## TRANSMITTAL MEMO

The applicant is submitting a request for an Encroachment Agreement Addendum for the property located at 175 S Glenwood St., legally known as LOTS 11-12, BLK 2, WORT-2, PIDN: 22-41-16-33-1-08-004

**Re: Glenwood + Simpson Mixed Use Building  
Summary of CDs Revision 9**

FIRST AMENDMENT TO DEVELOPMENT AGREEMENT

GRADING PLAN  
GLENWOOD

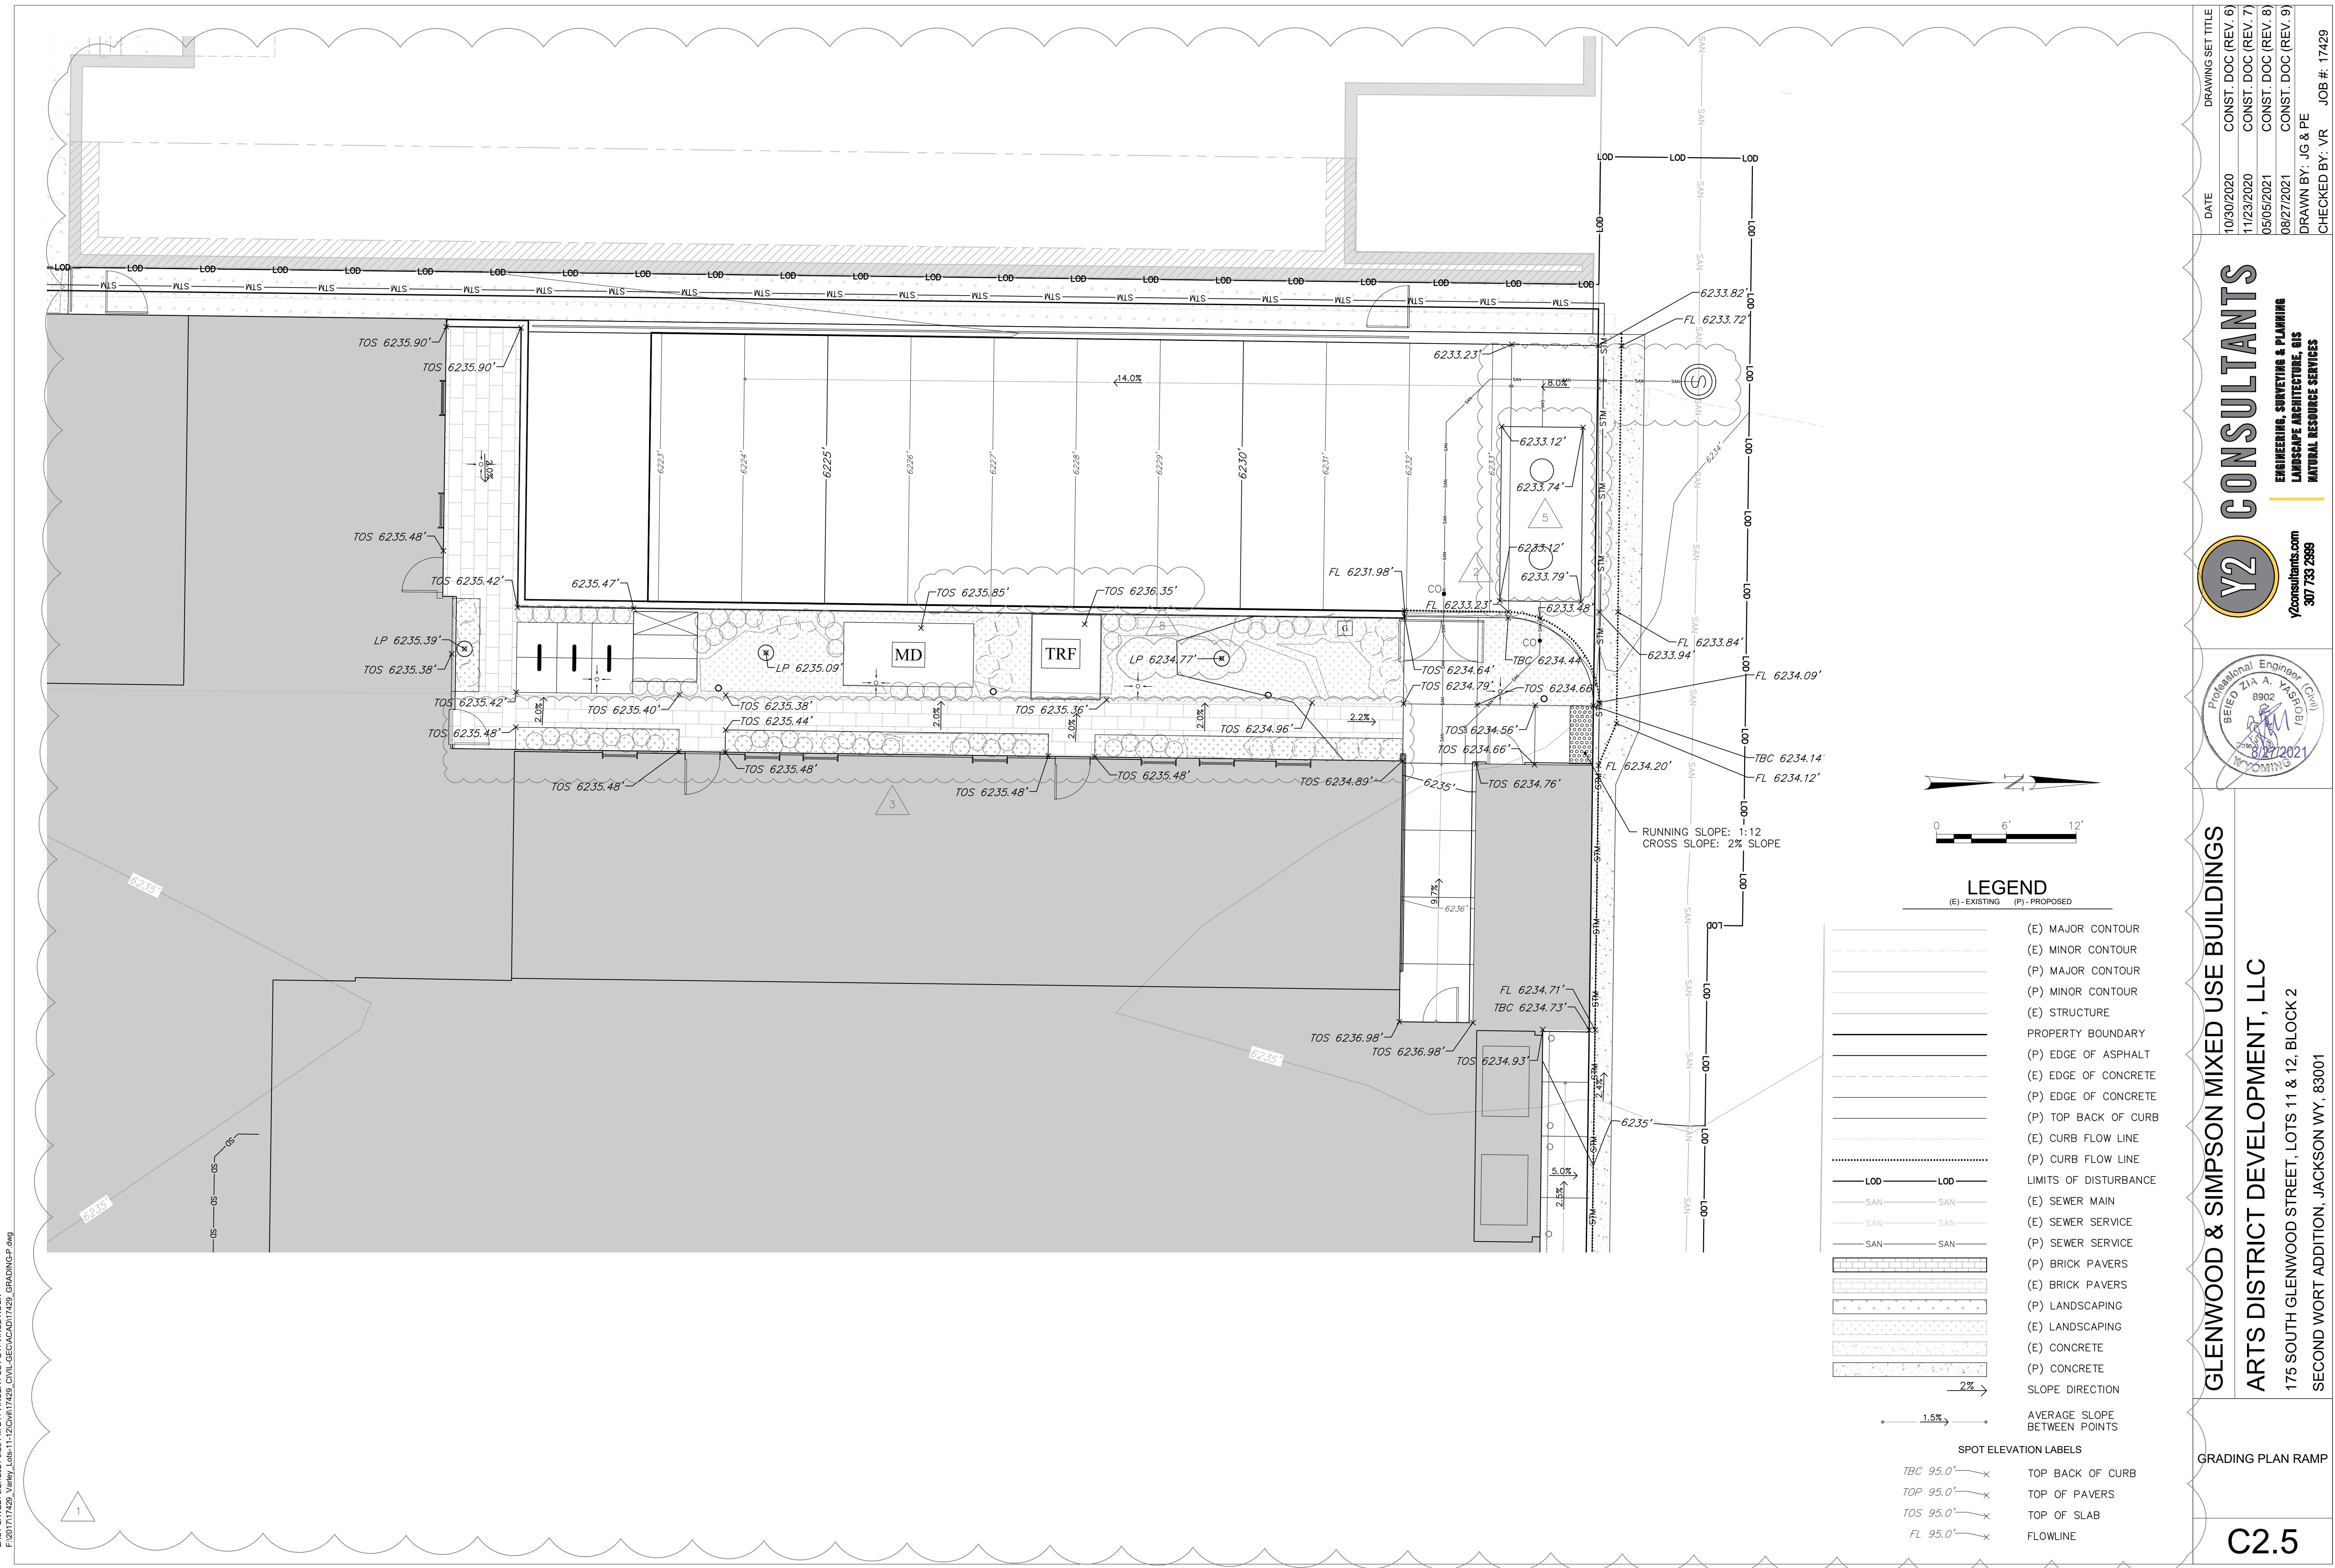
Sheet	Description	Description/Changes
C1.2	Finished Conditions	CenturyLink infrastructure relocated.
C2.1	Site Plan	Tree removed from northern-most landscape area.
C2.4	Grading Plan Glenwood	No parking sign location shifted south.
C2.7	Striping and Signage Plan
